AM 2 Revised Application - for Submission by email - Cross Gold Mine - M-1977- 410

GIR 110(2) Amendment 2 – Revision 1.0
 DRMS Comment and Resolution Sheet - Page 1 of 25
 Grand Island Resources, LLC. Responses

Project: CROSS AND CARIBOU MINE - AM 2 APPLICATION	Project No.: 21-1306	 REVISION 2 MAP 05
Location: NEDERLAND, COLORADO, USA	Date: NOV. 2021

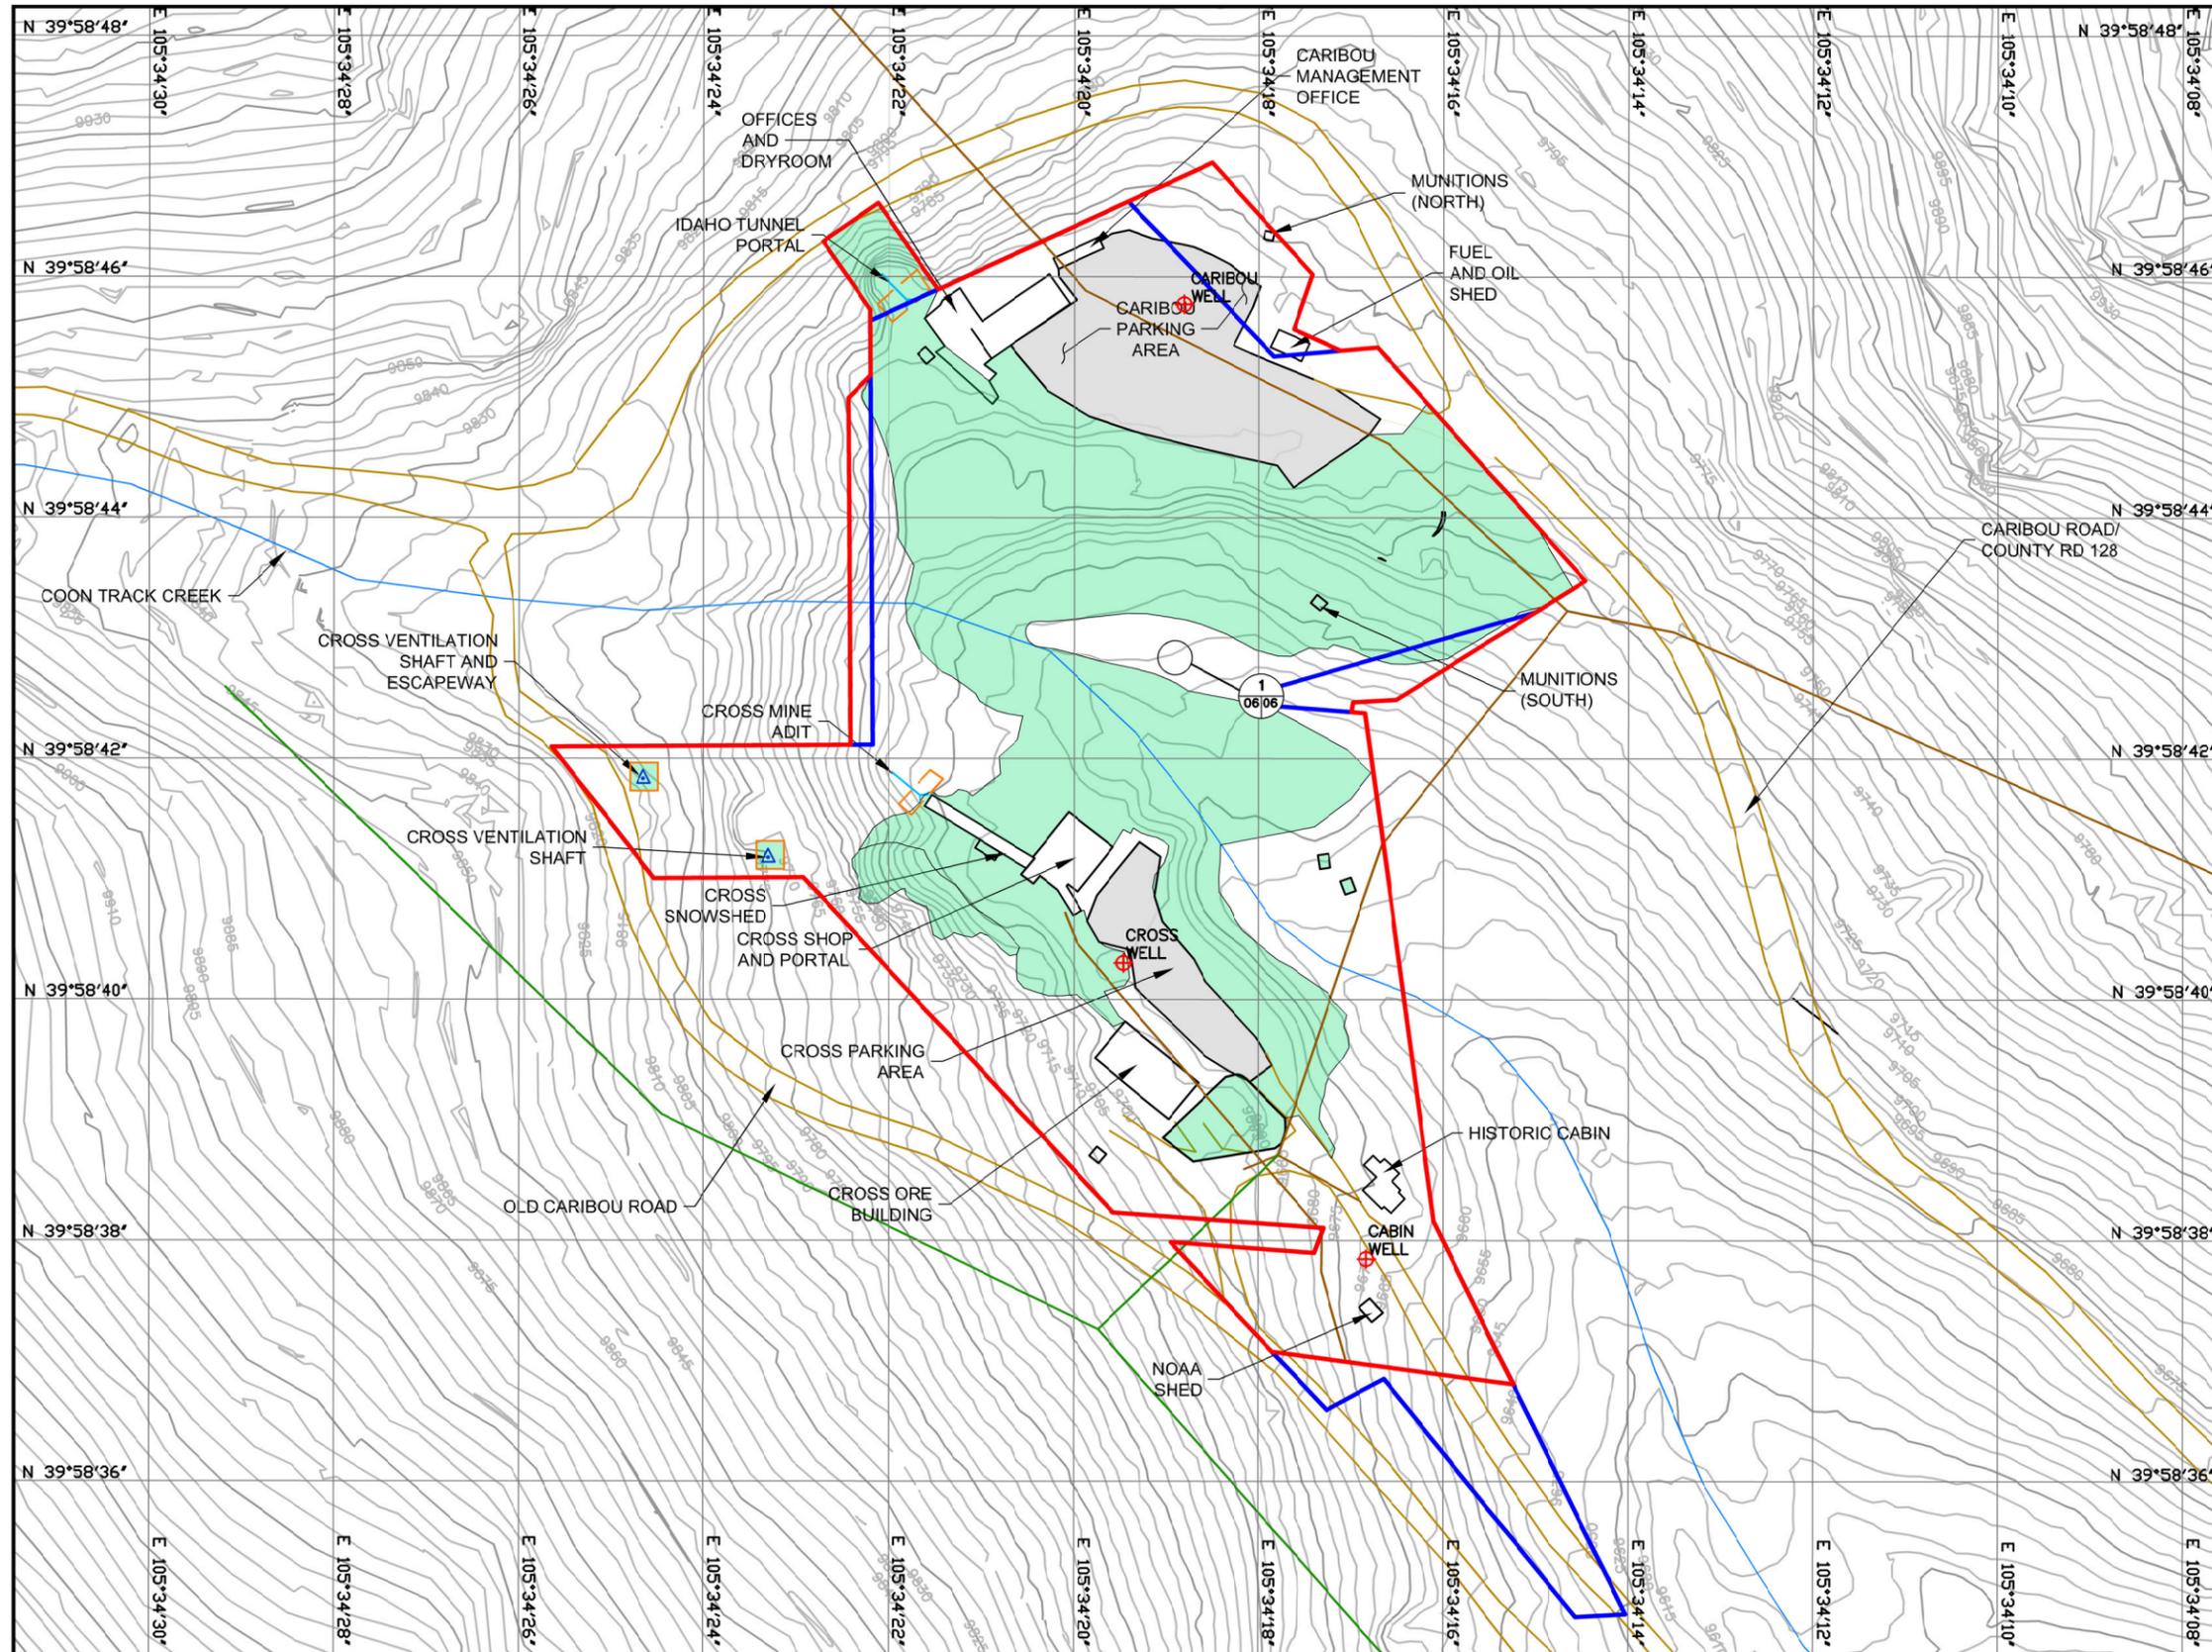
47	13	<p>Exhibit E – Maps (Rule 6.3.5)</p> <p>This exhibit includes a separate reclamation plan map (Map 8) for the Cross/Caribou site which shows facilities proposed to remain for reclamation. Please ensure all structure/features proposed to remain in Exhibit D are shown and labeled on this map, and that all structures/features shown on this map are included in the list</p>	<p>This map is now Map 6 and has all the remaining structures area listed in Exhibit D, Section 1.13. The ‘mill building’ label was removed. This is the Cross Ore Building.</p>
